ADDENDUM NO. [3] Date: March 29, 2018

RE: WESTERN TECHNICAL COLLEGE

ARC LIBRARY REMODELING & VETERAN'S CENTER ADDITION

400 SEVENTH STREET NORTH LA CROSSE, WISCONSIN 54601 HSR PROJECT NO. 17026

PARTIAL SECOND FLOOR LOW VOLTAGE PLAN

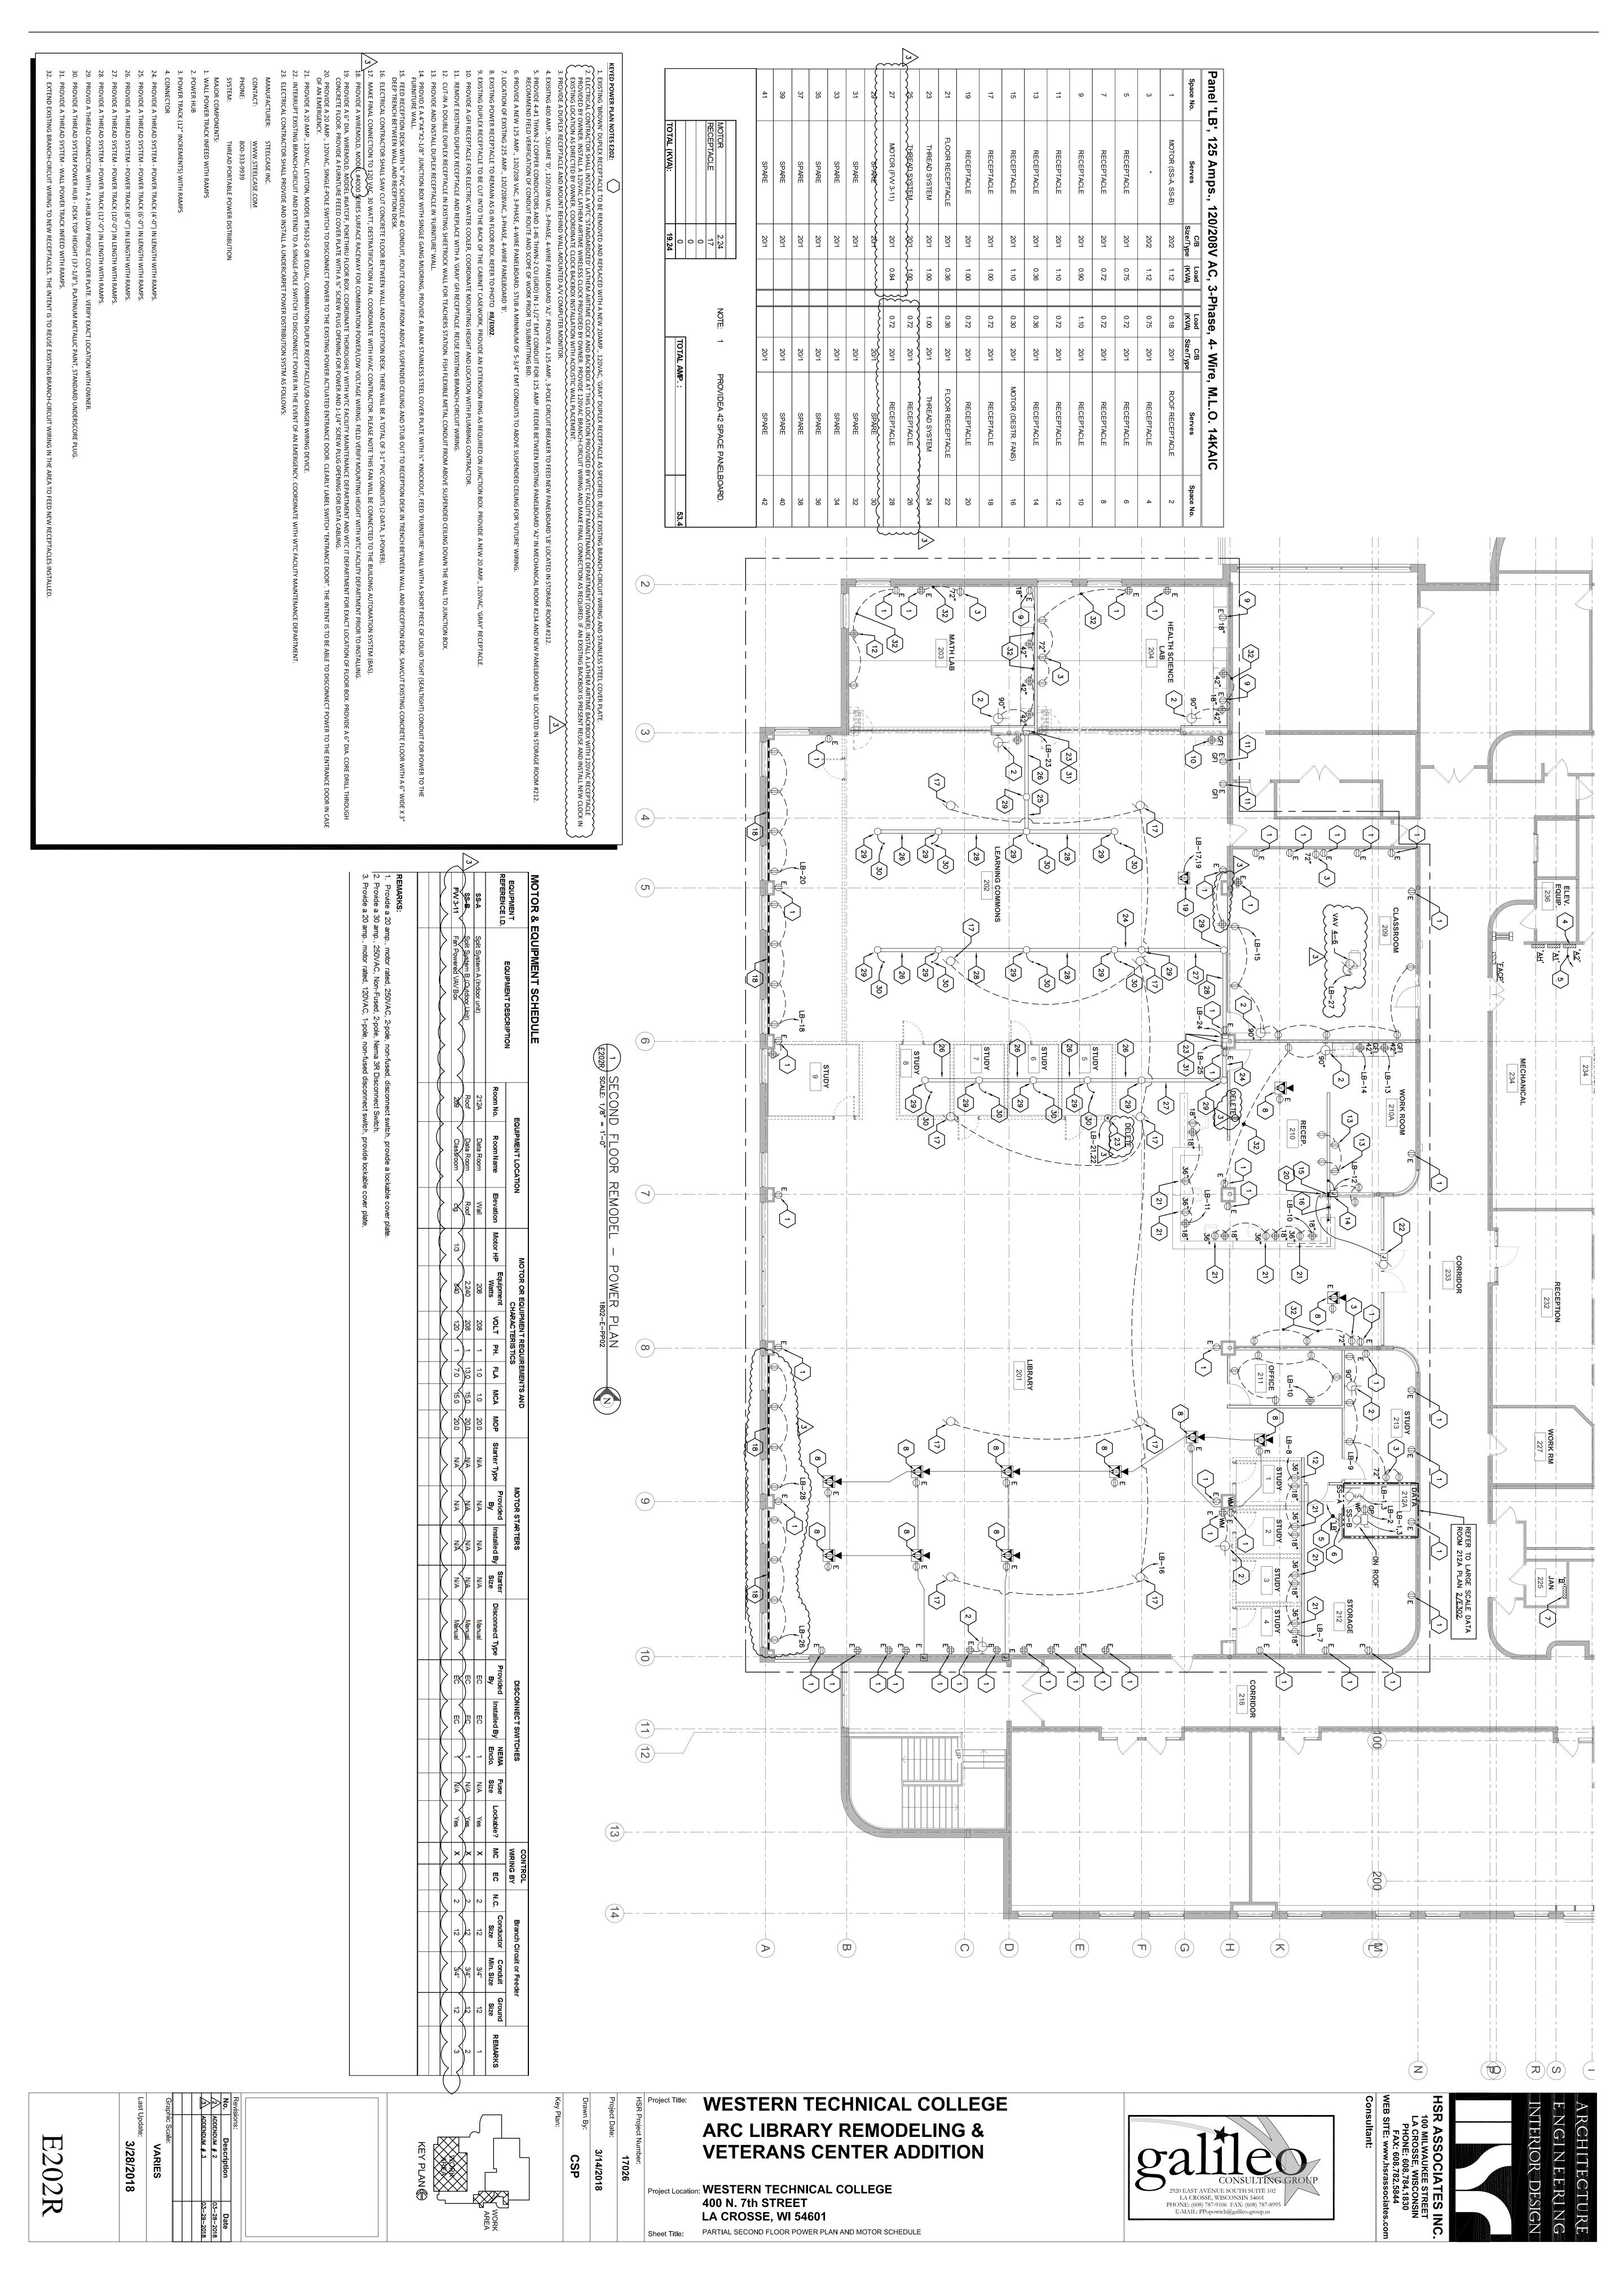
- i. Equipment/Motor Schedule: Fan powered FV V 3-11 added to the schedule, refer to clouded change.
- 5. Sheet E302R1 SECOND FLOOR REMODEL LOW VOLTAGE PLAN 30 x 42 attached hereto

- a. One (1) 1-port data jack is added on the West Wall in Study #9 in the Library #201. Refer to clouded change.
  - b. Keyed note #6 shall change from 2-port data jack to 1-port data jack. Refer to clouded change.
